**FINAL DECISION AND RESPONSE TO COMMENTS
ON SELECTION OF CORRECTIVE MEASURES UNDER SECTION 3008 (h) OF THE
RESOURCE CONSERVATION RECOVERY ACT**

**AMETEK U.S. GAUGE DIVISION – PLANT #2
SELLERSVILLE, PENNSYLVANIA**

ATTACHMENT 1
Response to Comments

Figure 1- TI Boundary

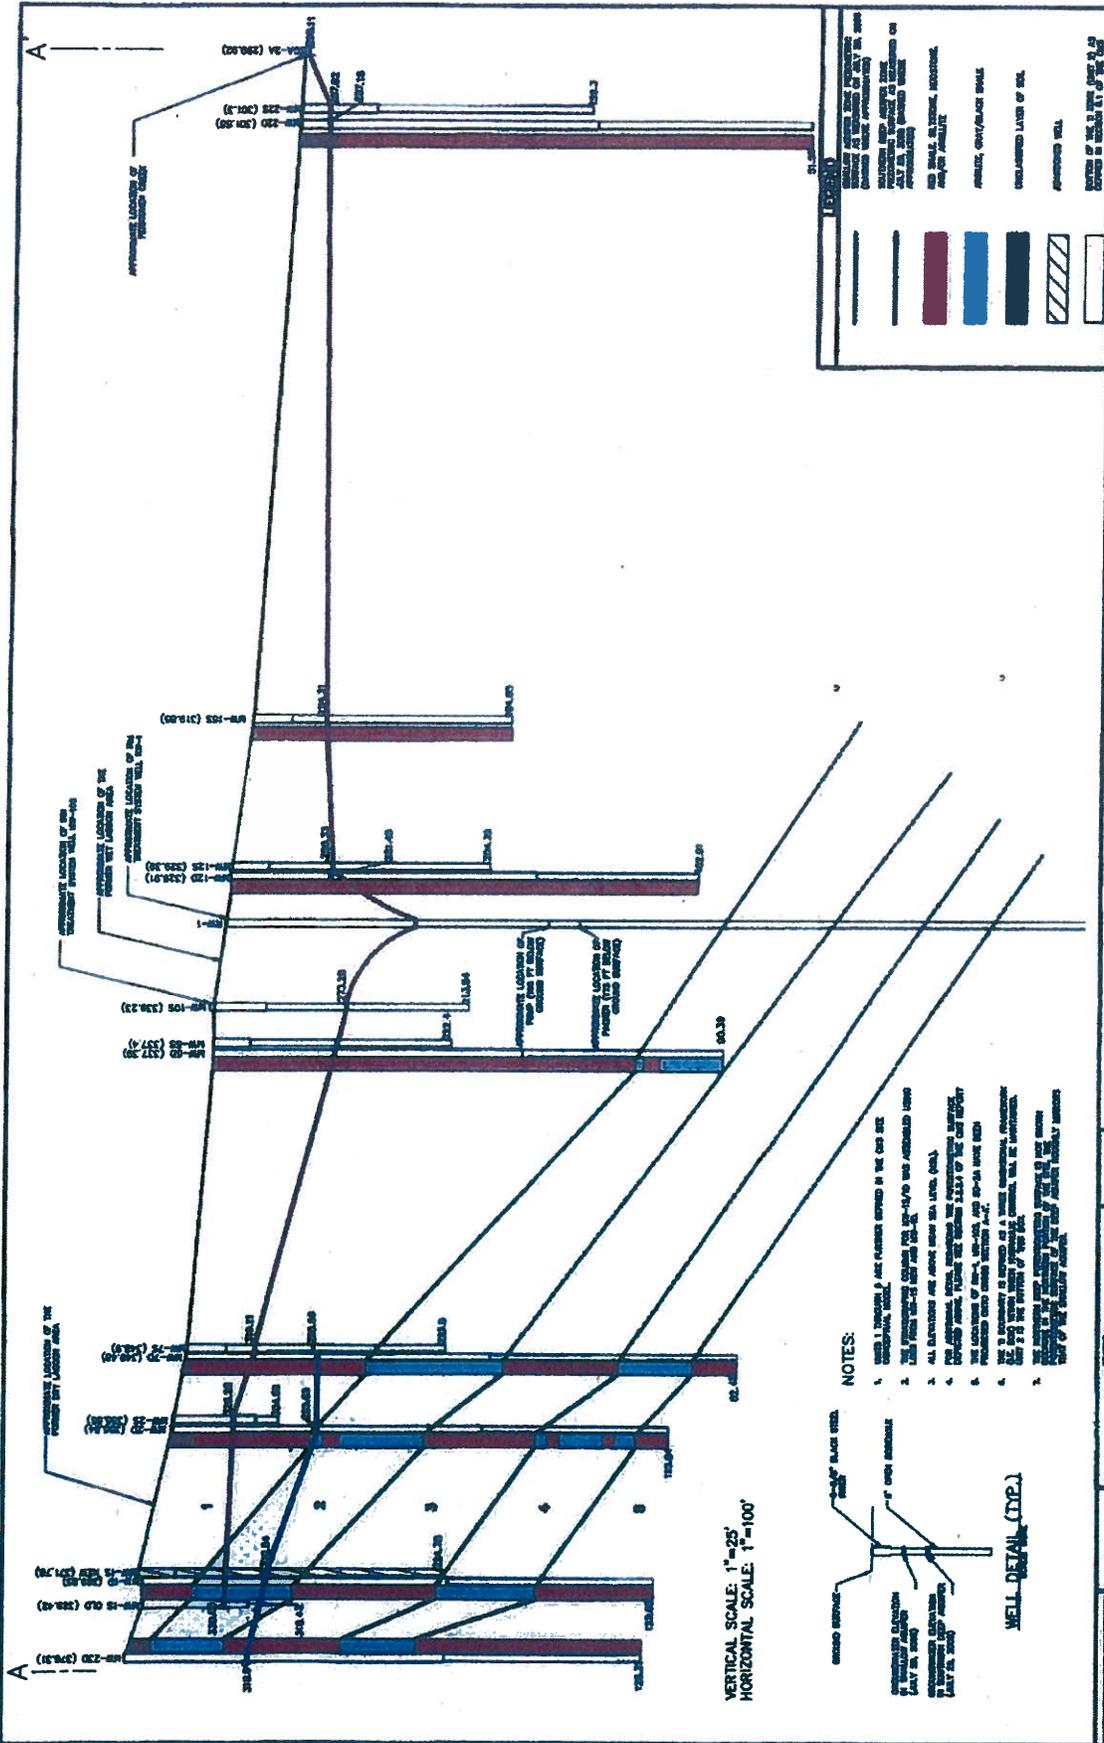
8. Comment: Clarification is needed regarding exactly what specific area is covered within the "TI" boundary.

19. Comment: Clarification is needed regarding exactly why the EPA was consistently ambiguous in stating that the ground under the private residences within the previously noted subdivisions is in fact a part of the "TI Zone." The wells within the "TI Zone"

work to ensure that the high-level/untreatable contamination remains within/does not extend beyond this zone [i.e. remains underneath the homes in question]. The only wells in Figure 1 on page 18 of the Statement of Basis that are NOT included in this zone are 21D, 21S, 22D, and 22S. All other wells noted in blue--both inside AND outside Ametek's property line--are a part of this zone, and it is within this zone that contamination levels will remain above legal and health limits. Based upon Malcom Pirnie reporting, the establishment of "Technical Impracticability" for this zone means that toxic levels will stay above legal MCL limits here, but the pump-and-treat/monitoring well system will ensure that contamination does not spread BEYOND here. In light of the info relayed in comment #13, clarification is needed regarding the future deed restrictions reflecting permanent land use prohibitions for all residences located within this "TI Zone," and how they--coupled with myriad health-related concerns--will have tremendous impact on residents, property values, and the homeowners' ability to resell their homes. Those who live in the affected areas need to be advised that 1) their property is permanently impaired, 2) they have been living on top of carcinogenic toxins unknowingly for decades, and 3) their health, homes, and financial security have been/will negatively [sic] affected as a result.

EPA Response: The designated TI boundary is the Ametek Plant #2 property boundary, which is shown graphically in Figure 1 of the Statement of Basis.

EPA Response: Please see EPA response to comments #13, 16, 17 and 18. The TI Zone consists of only the Ametek Plant #2 property. No other properties are located within the TI Zone.

Figure 2- Geologic Cross Section

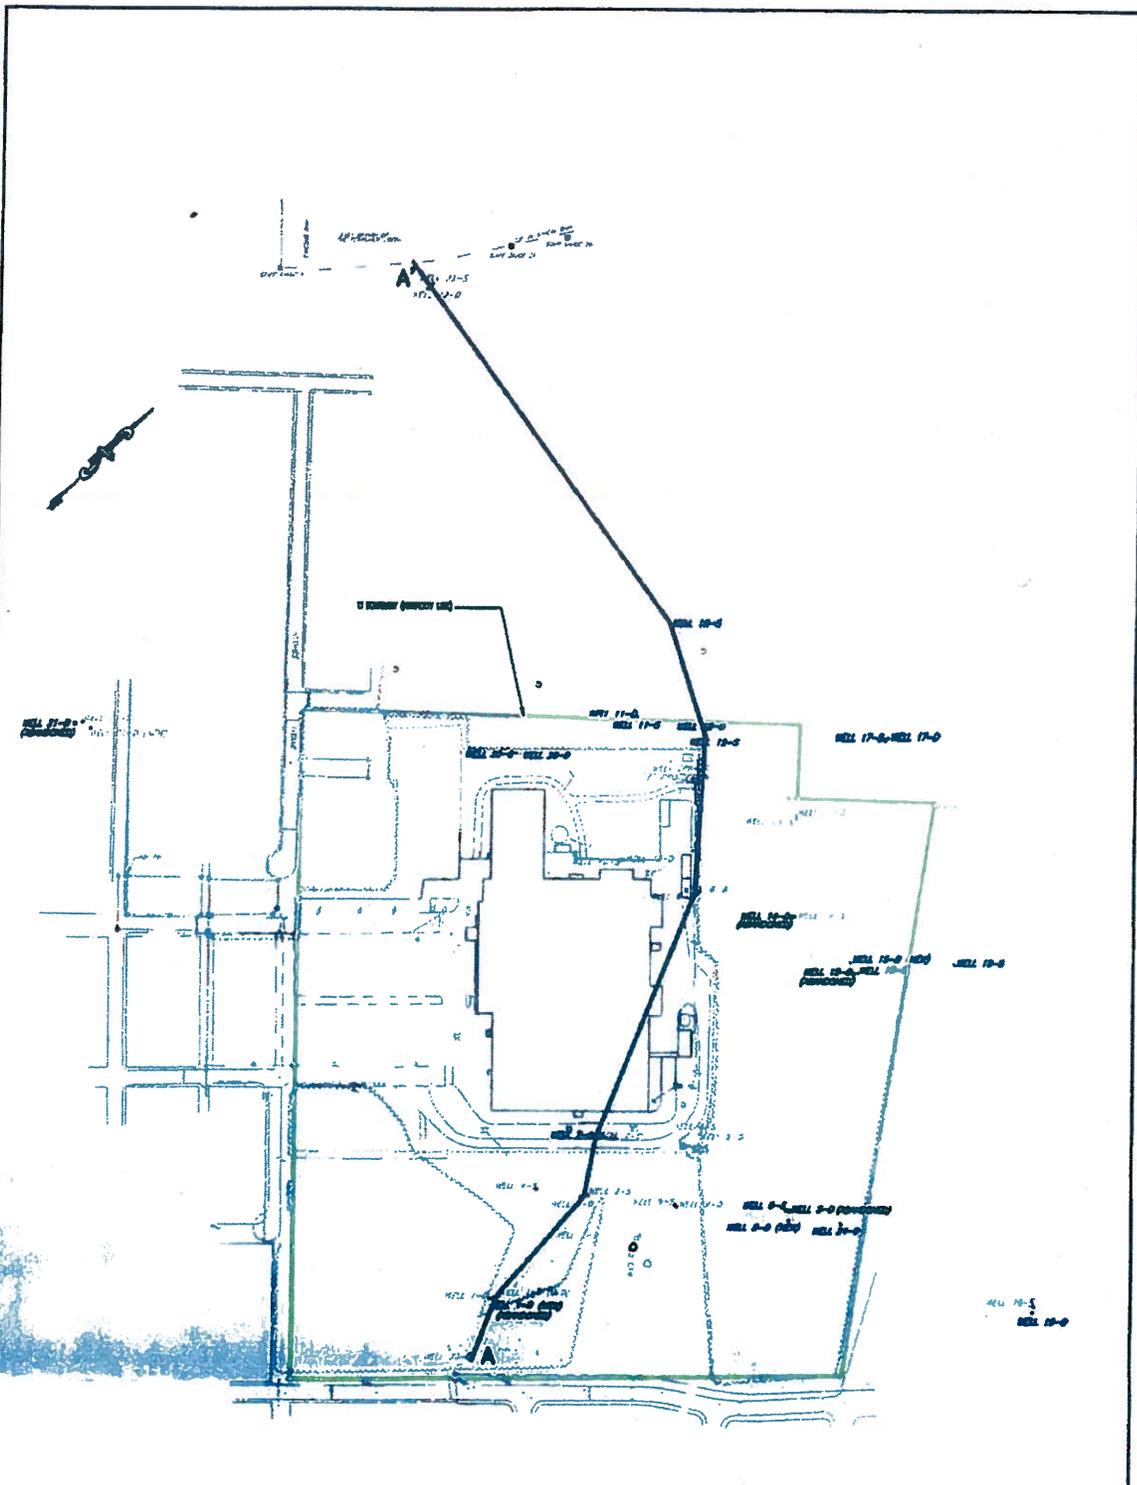
15. Comment: Clarification is needed regarding why the B-B cross-section, as referenced in various Malcom Pirnie reporting, was omitted from the Statement of Basis. This cross-section represents the COC path of the most contaminated portion of Ametek's property

EPA Response: The purpose of the SB document is to summarize the investigation and to present the proposed remedy. The attached A-A cross-section to the SB document presents key features that pertain to the proposed remedy such as the contamination source areas (Former Wet Lagoon and Former Dry Lagoon Areas) where the highest levels of TCE are detected and the location of active groundwater extraction and treatment system recovery wells.
